Re: Roosevelt Industrial Park Expansion
Aberdeen, SD
Helms A-9767

ADDENDUM NUMBER 1

The following modifications are made to the plans and specifications for the Roosevelt Industrial Park Expansion; Aberdeen, SD.

Industrial Avenue NE
Plan (Sta. 11+00 to Sta. 16+50)
ROOSEVELT INDUSTRIAL PARK IMPROVEMENTS
ABERDEEN DEVELOPMENT CORP
ABERDEEN, SOUTH DAKOTA

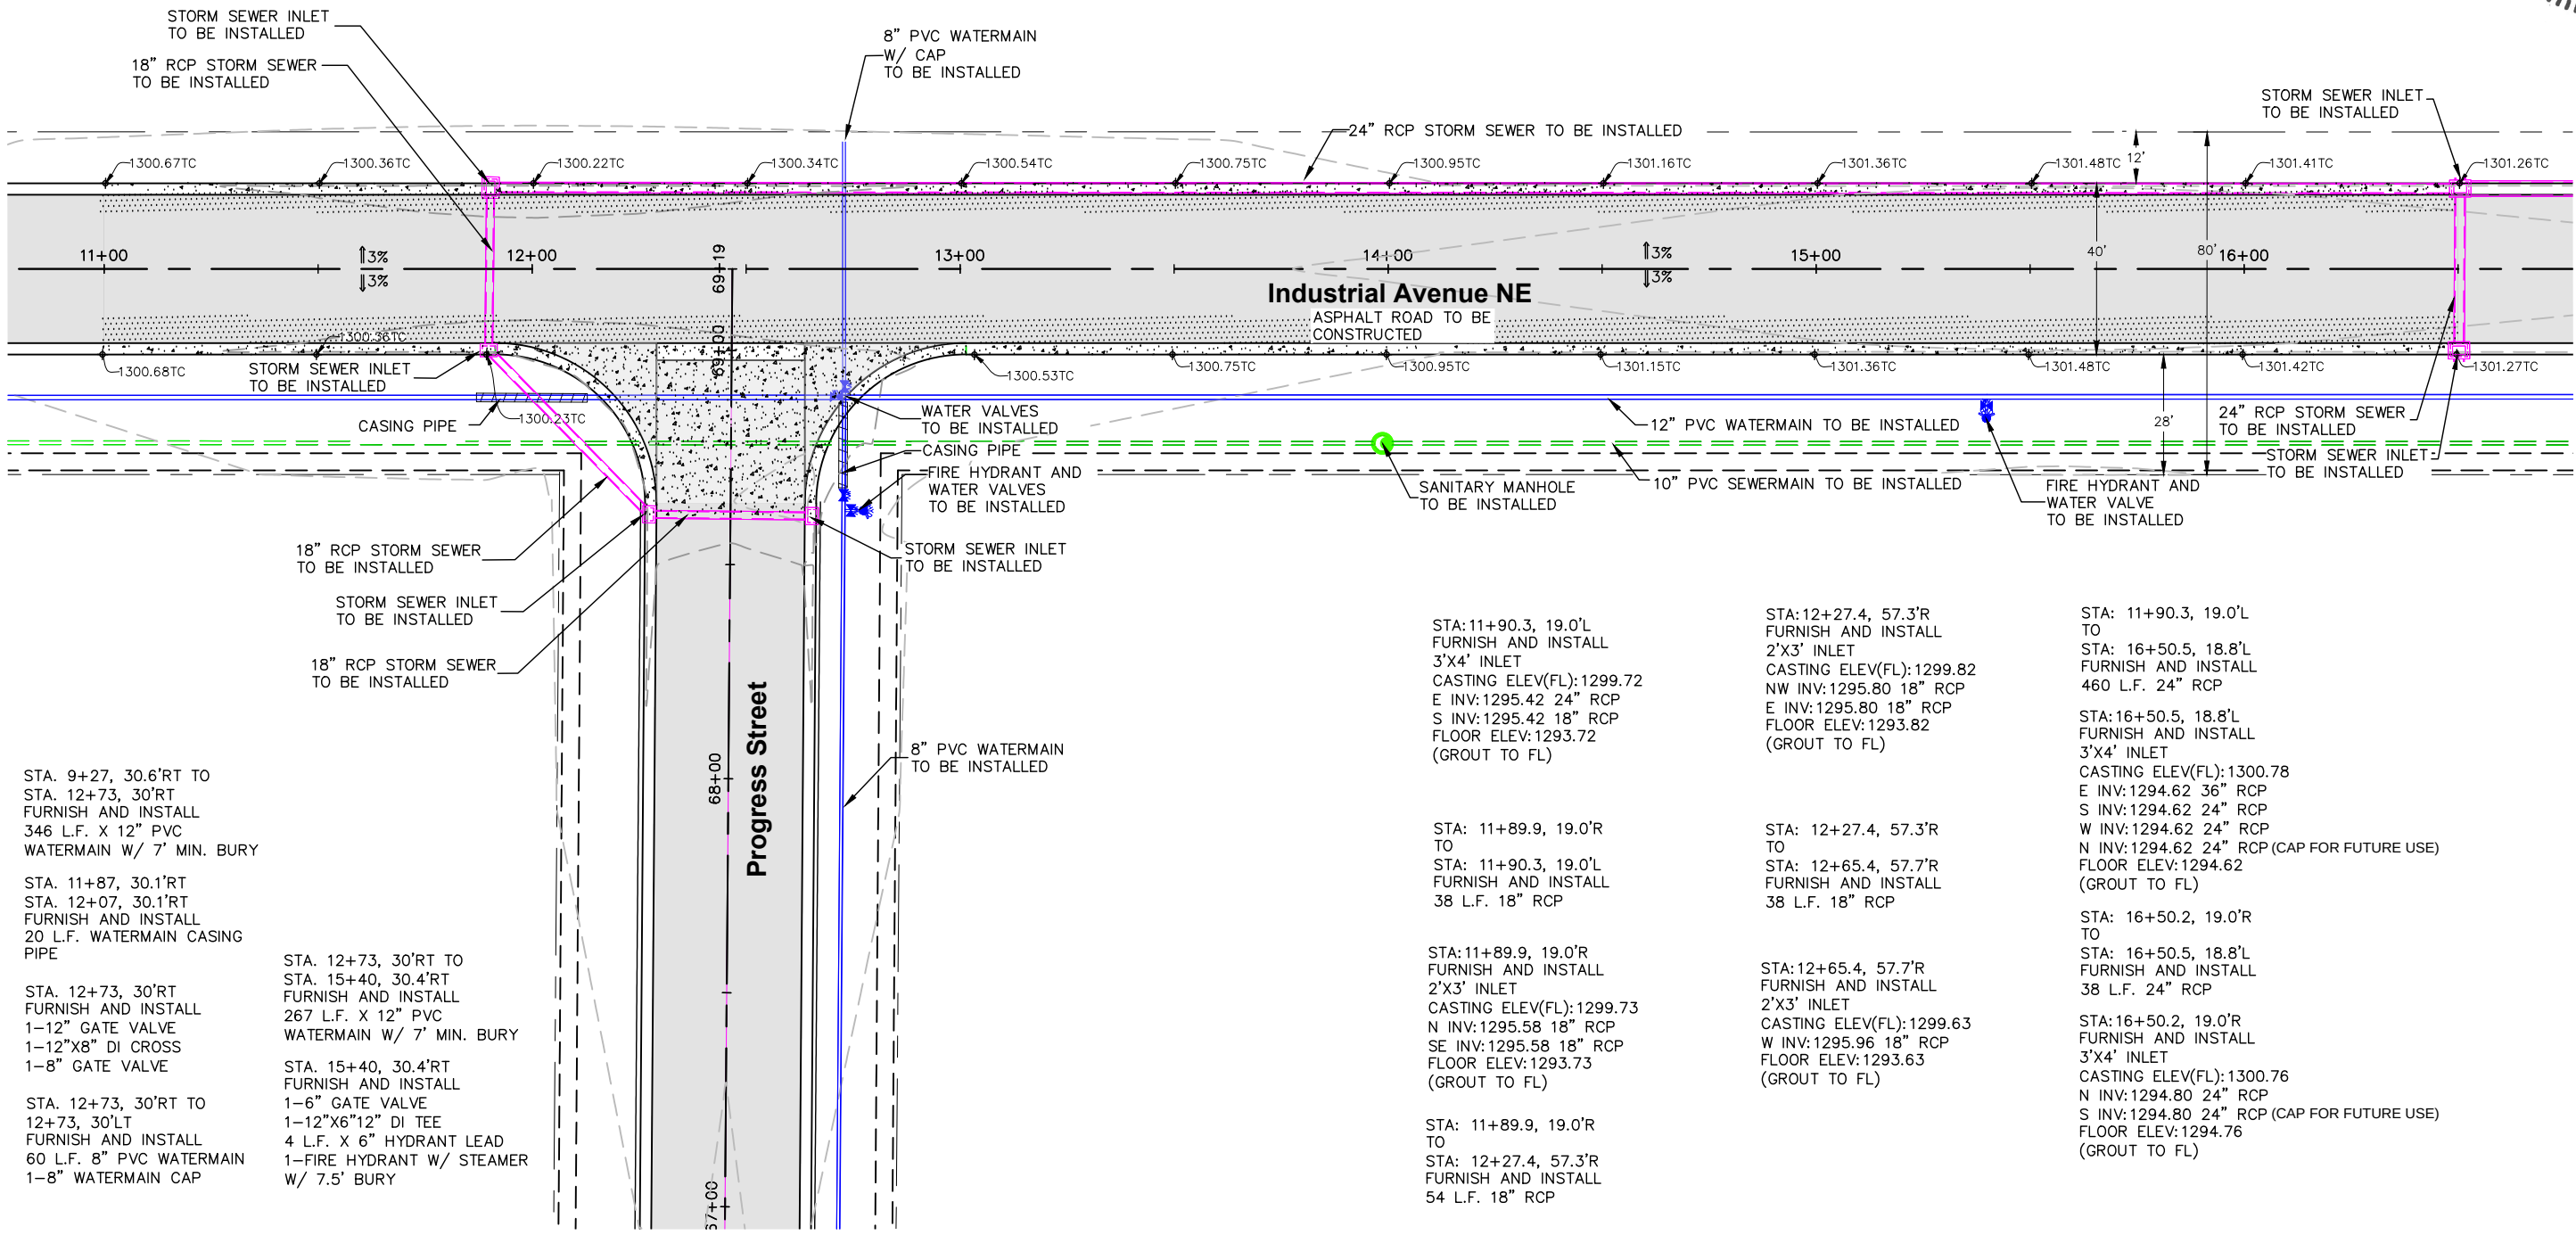
3.) Revision of Storm Sewer Inlet elevation information, Plan Sheets 18,22,24,26,28,31,33, and 41 of 63:

Floor elevations for storm sewer inlets have been revised. Also note, the storm inlets at Station 16+50 (Sheet 22) indicate new north and south inverts. These are for future use and 24" storm piping shall be stubbed out and capped (Bid Item 43). Please remove and replace with the attached revised Sheets 18,22,24,26,28,31,33, and 41.

DETAILS

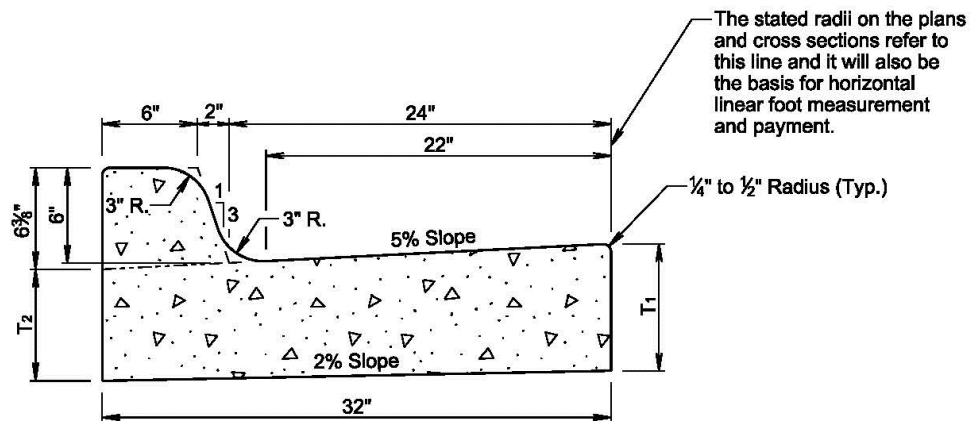
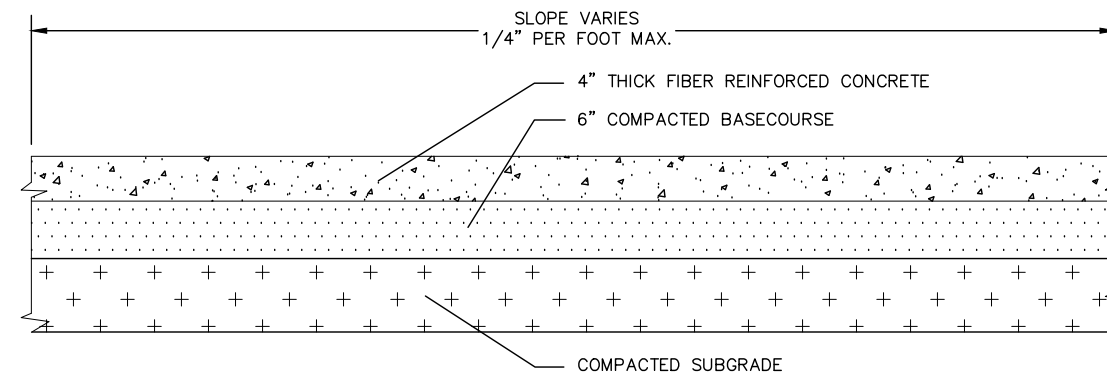
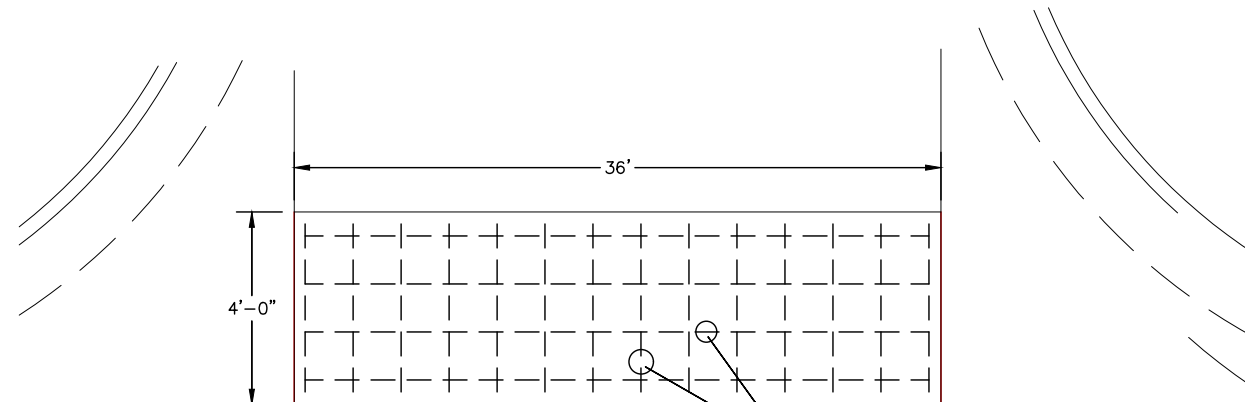
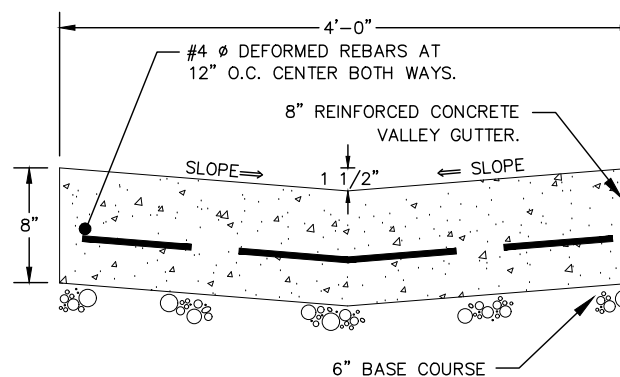
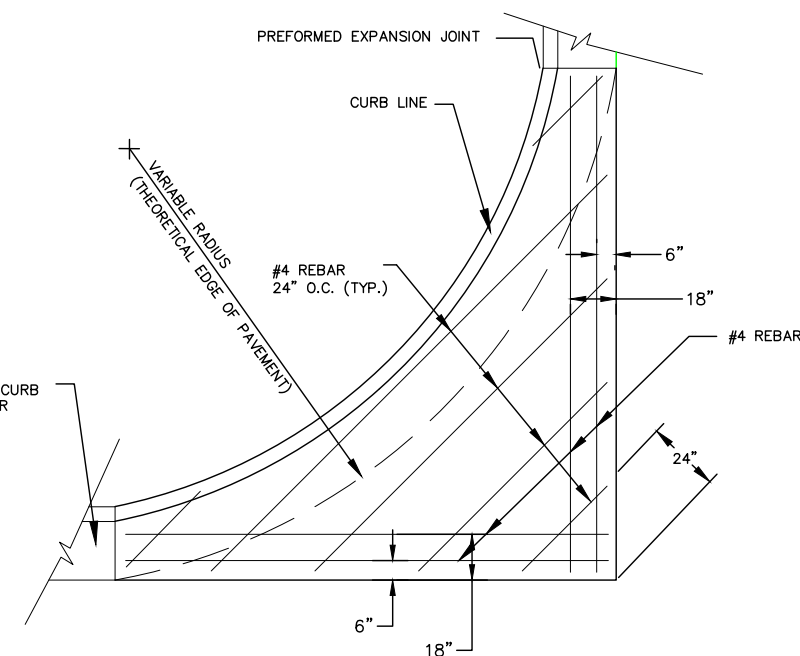
4.) Clarification of Type B Curb and Gutter, Plan Sheet 53 of 63:

Type B68 shall be used for the 32" wide curb and gutter. Original highlighted detail was mistakenly blacked out. Please remove and replace with the attached revised Sheet 53.
